Presentation to the Planning Panel on the Armstrong Creek Urban Growth Plan

Geelong Branch of the Public Transport Users Association

Figure 1: Duplicated bus routes required to serve the Sub-Regional Centre site.

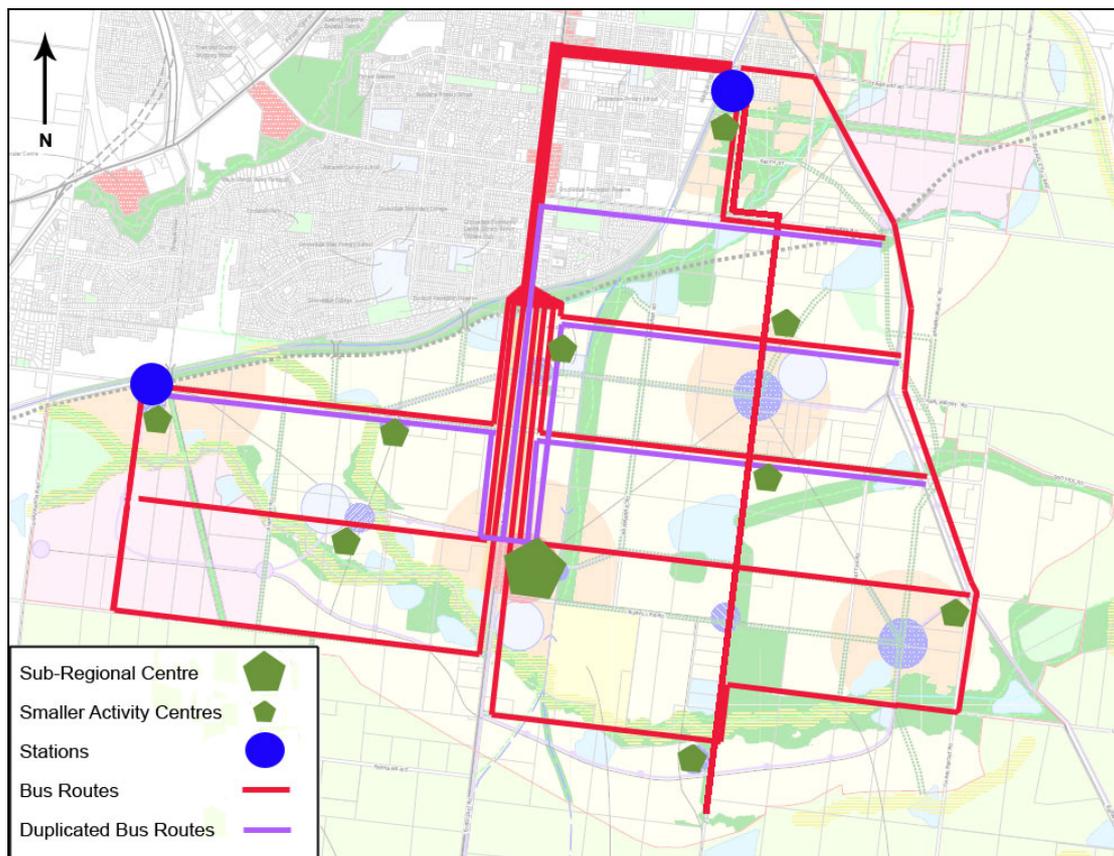
In fact, most buses would still need to serve the area's two main destinations in addition to serving residential areas, except that the destinations would now be far apart and in opposite directions; Marshall station in the north-east and the sub-regional centre in the south. Many routes would need to be split, leading to inefficient duplication and poor service quality (see *Figure 1*).

Figure 2: A more efficient public transport network with the Sub-Regional Centre next to a station on the existing railway line.

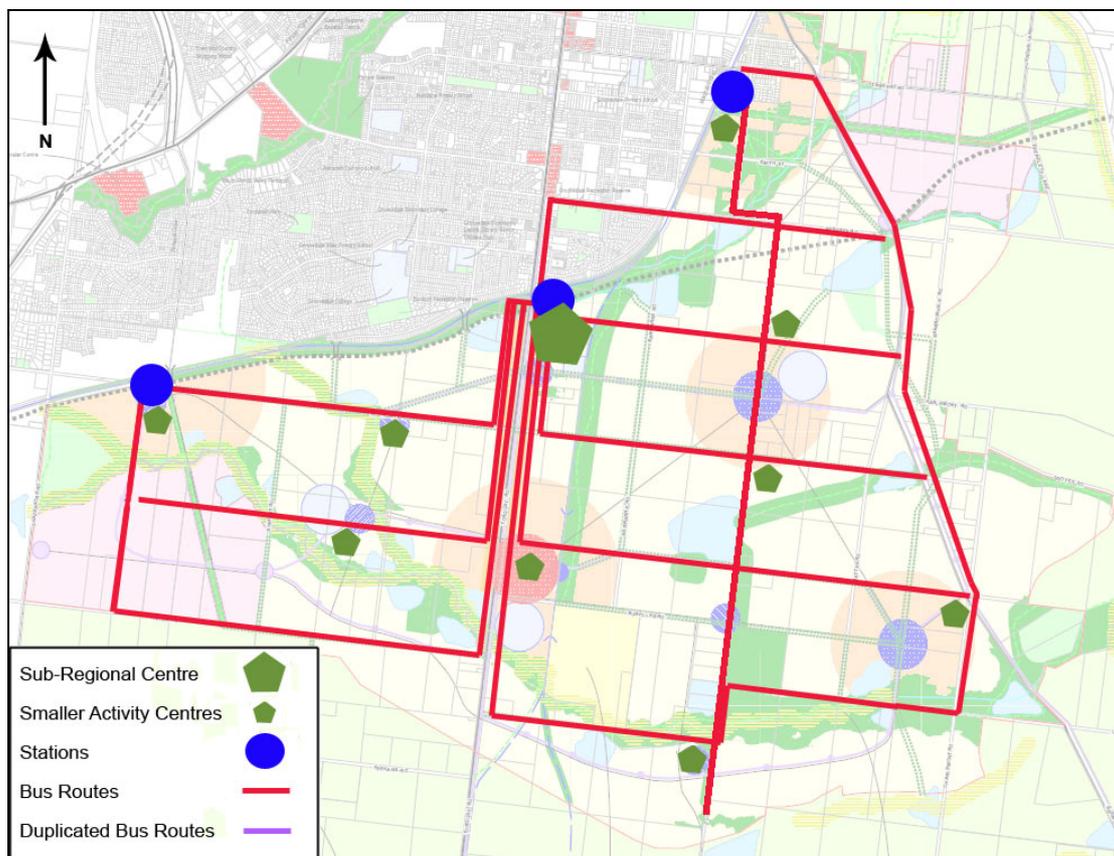
Locating the sub-regional centre at that site will place the area's largest activity centre in an excellent location for convenient access by existing fast, high capacity rail services, without requiring the building of a new railway line. It will also ensure that there is one focal point for the local bus system, allowing buses to serve local travel to the activity centre, the railway station and to the existing urban area north of the line at the same time (see *Figure 2*).

We therefore suggest that the sub-regional centre (with provision for a new railway station) should be established at a site next to the existing level crossing on the Surf Coast Highway.

Figure 3: Bus routes serving the preferred Sub-Regional Centre site before the construction of a station on the existing railway line.

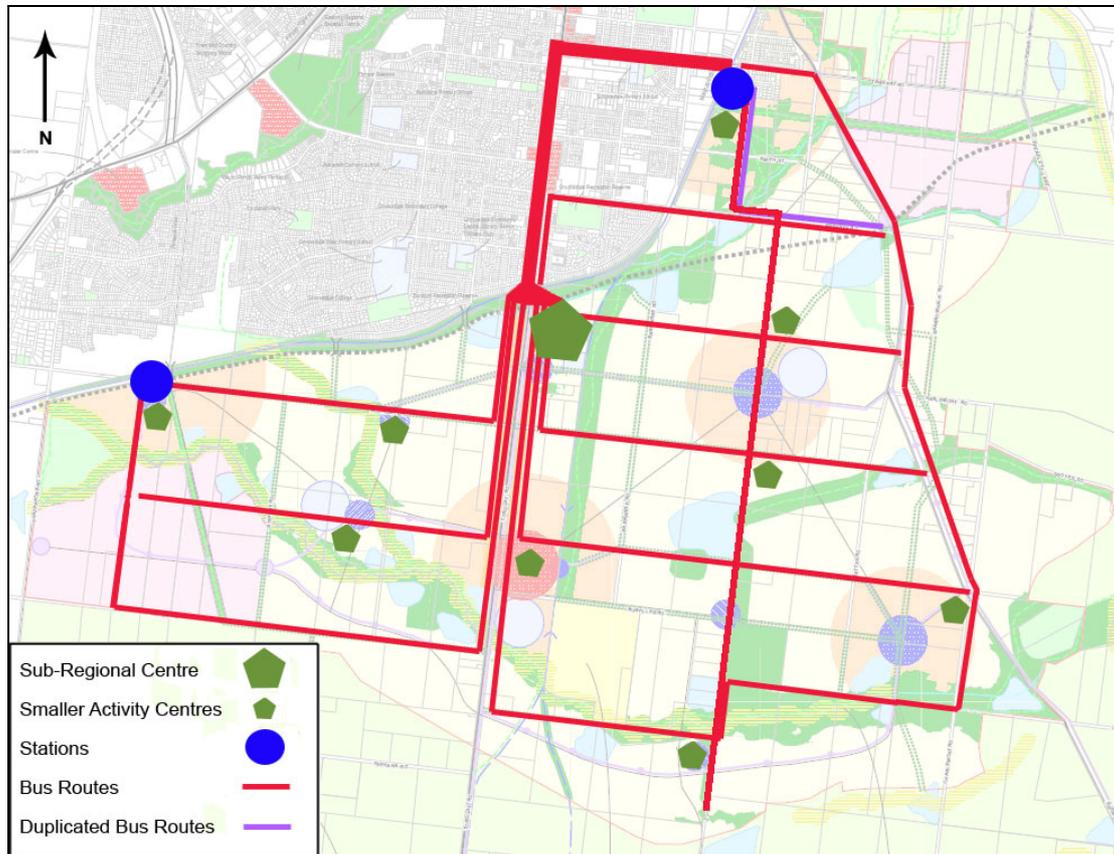
Even before a Surf Coast Hwy station is built, most bus services could still travel past the shopping centre and continue on in the same direction to connect with trains at the existing Marshall station (see *Figure 3*). With a station at the Surf Coast Highway however, bus routes will be shorter and more efficient.
